SUNDRY	NOTICES	ΔND	REPORTS	ON	WELL	S

#### Pure Gold A Federal #14 API No. 30-015-35307

## Pure Gold A Federal 14 30-015-35307 OXY USA Inc. October 24, 2011 Conditions of Approval

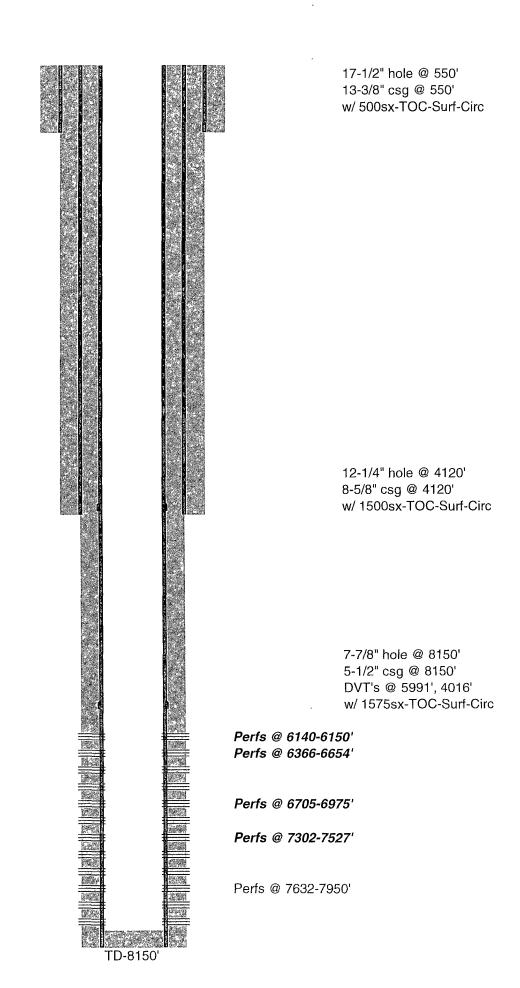
- 6. Proposed uppermost perforations are in the Cherry Canyon.
- 7. Operator limited to 3300 psi on the frac down the casing. This is based on 70% of the 5.5" 15.5# J-55 casing's burst rating.

- 8. Operator to submit a subsequent sundry with details of work performed including a new well test.
- 9. Since the uppermost new perforations will penetrate the Cherry Canyon, a new completion report is required with production for each interval. Operator has the option of eliminating the uppermost perforations and a completion report will not be required. If all perforations are open, a downhole commingle approval will be required.
